MEMORANDUM

SUBJECT Cupertino De Anza Hotel Project Initial Study and Mitigated Negative Declaration
Responses to Comments Memo for City Council

TABLE 1 RESPONSES TO LATE COMMENTS ON THE PUBLIC REVIEW DRAFT INITIAL STUDY AND MITIGATED NEGATIVE DECLARATION

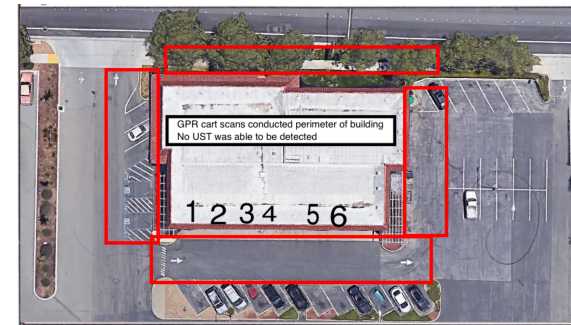
Number	Comment/Response
Comment 2-4	<p data-bbox="344 345 688 375">Hazards and Hazardous Materials</p> <p data-bbox="344 383 1913 505">The subject property very likely has an underground storage tank (“UST”) that contains waste oil. In the MND, the Applicant admits that the geophysical survey was performed only “within accessible areas of the site”. A substantial surface area of the site was ignored, and no borings were performed, due to limited accessibility. This is discussed in Section VIII, Hazards and Hazardous Materials, on page 4-44 and page 4-47 of the MND. As a result of this limited investigation, the applicant has not found the location of the UST.</p> <p data-bbox="344 545 1913 607">Nonetheless, the Environmental Data Resources (EDR) records show that the UST was installed at the project site in 1973. There is no record of the UST removal. Therefore, one can and should conclude that a UST remains buried somewhere on the site.</p> <p data-bbox="344 651 1913 740">The Response Memo attempts to avoid this issue by claiming that the chances of finding the UST are low. It continues by stating that even if the UST is discovered during grading of the site, the developer will simply comply with California law and sample the soil, remove the tank, clean up any toxins, and proceed with the project.</p> <p data-bbox="344 784 1913 846">We know that the project will have four levels of subterranean parking. The massive hole that must be created to allow for this underground garage is certain to come upon the UST. Before the digging begins, we must understand the nature and extent of the contamination.</p> <p data-bbox="344 889 1913 1008">There is substantial evidence that the UST exists now. CEQA does not allow the City to defer the nature, type and specification of a mitigation measure. In this case, if the UST has leaked and contaminated surrounding soil and possibly groundwater, the whole cleanup process will be an unknown new project. For this reason, the City should require as much additional boring and testing as may be required until the UST is identified. Then, the soils samples should be taken to confirm whether or not contamination has occurred. Then, when the facts are known, the City can require an appropriate mitigation measure.</p>

Response 2-4	<p data-bbox="344 1016 1913 1263">The commenter correctly states that the site could contain a 200-gallon waste oil UST, as discussed in Section VIII, Hazards and Hazardous Materials, on page 4-44 and page 4-47 of the IS/MND. The commenter incorrectly asserts that the IS/MND includes deferred mitigation. Although CEQA Guidelines Section 15126.4 prohibits the formulation of mitigation measures to be deferred until some future time, the IS/MND concluded that the impacts due to potential discovery of an underground storage tank during construction would be less than significant, because the project would comply with mandatory regulations applicable to removal and closure of underground storage tanks and remediation of any associated contamination. As stated in the CEQA Guidelines Section 15126.4(a)(1)(B), compliance with a regulatory permit or other similar process may be identified as mitigation if compliance would result in implementation of measures that would be reasonably expected, based on substantial evidence in the record, to reduce the significant impact to the specified performance standards.</p>

As described in the IS/MND on page 4-44, a Phase I Environmental Site Assessment (ESA) dated August 8, 2018 was prepared for the project site by AEI Consultants (See Appendix E of the IS/MND).² The purpose of the Phase I ESA was to identify potential Recognized Environmental Conditions (RECs) associated with the presence of hazardous substances or petroleum products in the vicinity of the project site. Note that the Phase I ESA also evaluated Controlled RECs, which are locations where the past release of hazardous materials has been addressed to the satisfaction of the applicable regulatory authority, with hazardous substances or petroleum products allowed to remain in place subject to the implementation of required controls, and Historical RECs, which are also satisfactorily addressed but are not subject to any required controls.

As described in the IS/MND, the site supported agricultural land uses between 1939 to 1968. The existing building was built in 1971 and 1972 and the tank was installed in 1973. Therefore, the UST, if still underground, has been there for 47 years. As described in the IS/MND, the possibility that the UST could still be on the site remains because there are no records of the tank being removed (see page 4-47 of the IS/MND). For this very reason, as part of the Phase II ESA, ground penetrating radar (GPR) was conducted around the “accessible areas,” which are the perimeter areas around the building structure. These areas are described as accessible because the GPR cannot be performed where the building is located. The image of the accessible area is shown here in the red boxes surrounding the existing building and in Appendix B of the Phase II ESA.
